Functional Differences Between The 1F90S Mask of the DSP56302 and the 0J17D Mask of the DSP56309

This document summarizes the differences between the DSP56302 (1F90S mask revision) and the DSP56309, Rev A (0J17D mask revision). Rev A of the DSP56309 is functionally compatible with the DSP56302, allowing seamless transition to the higher-performance DSP56309. The 0J17D mask of the DSP56309 uses the communications design rules (CDR2) process. The 0J17D mask set also has new I/O and a new PLL, with the requisite change in the PLL capacitor equation (PCAP).

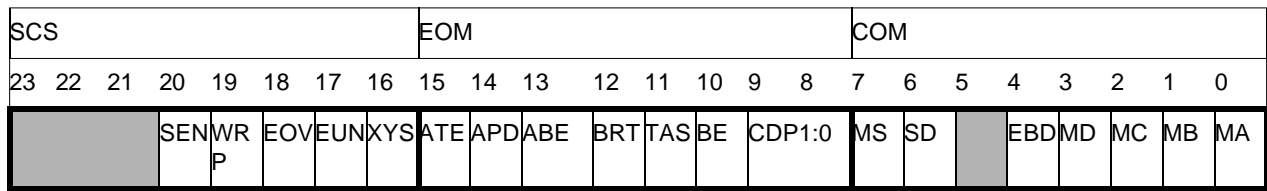
In the Operating Mode Register (OMR) of the 0J17D is a new Asynchronous Bus Arbitration (ABE) bit to support external access at high frequencies. As **Figure 1** shows, bit 13 in the OMR enables Asynchronous Bus Arbitration. For convenience, **Table 2** defines all the OMR bits available in the 0J17D mask set of the DSP56309. The ABE bit is highlighted in a bold red font.

13	ABE	0	Asynchronous Bus Arbitration Enable Eliminates the setup and hold time requirements (with respect to CLKOUT) for \overline{BB} and \overline{BG} , and substitutes a required non-overlap interval between the deassertion of one \overline{BG} input to a DSP56300 family device and the assertion of a second \overline{BG} input to a second DSP56300 family device on the same bus. When the ABE bit is set, the \overline{BG} and \overline{BB} inputs are synchronized. This synchronization causes a delay between a change in \overline{BG} or \overline{BB} until this change is actually accepted by the receiving device.	
12	BRT	0	Bus Release Timing Selects between fast or slow bus release. If BRT is cleared, a Fast Bus Release mode is selected (that is, no additional cycles are added to the access and BB is not guaranteed to be the last Port A pin that is tri-stated at the end of the access). If BRT is set, a Slow Bus Release mode is selected (that is, an additional cycle is added to the access, and BB is the last Port A pin that is tri-stated at the end of the ACCESS).

Figure 4. DSP56309 Thin Quad Flat Pack (TQFP), Top View

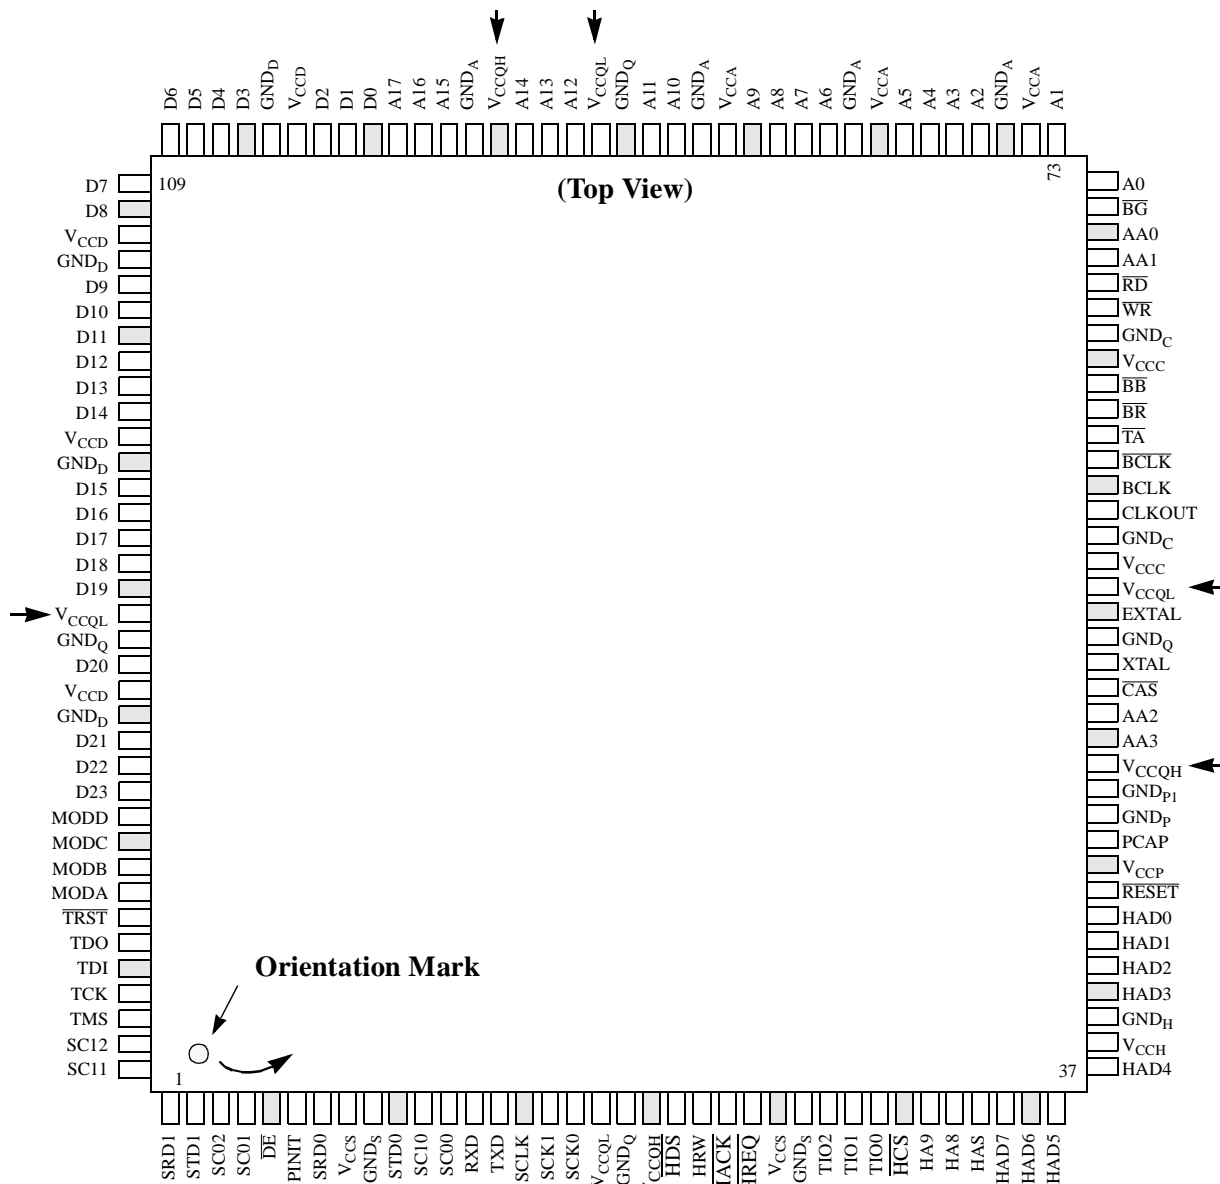
The DSP56309 Rev A uses a split-power design and therefore requires a modification in the chip pinout. A top view of the DSP56309 Rev A TQFP package is shown in **Figure 4**. **Table 3** lists the pin differences between the DSP56302 and the DSP56309.

Note: Arrows (→) indicate the pins that are different from the DSP56302, as listed in Table 3, on page 7.

Pin	Pin Name	
	DSP56302	DSP56309 Rev A
18	V _{CCQ}	V _{CCQL}
20	NC	V _{CCQH}
49	NC	V _{CCQH}
56	V _{CCQ}	V _{CCQL}
91	V _{CCQ}	V _{CCQL}
95	V _{CCA}	V _{CCQH}
126	V _{CCQ}	V _{CCQL}
Notes: <ol style="list-style-type: none"> 1. V_{CCQ} = input voltage for core logic 2. NC = not connected 3. V_{CCQL} = independent input voltage for core logic 3. V_{CCQH} = independent input voltage for I/O lines 4. V_{CCA} = voltage for external address lines 5. Unlisted pins are the same for both chips.
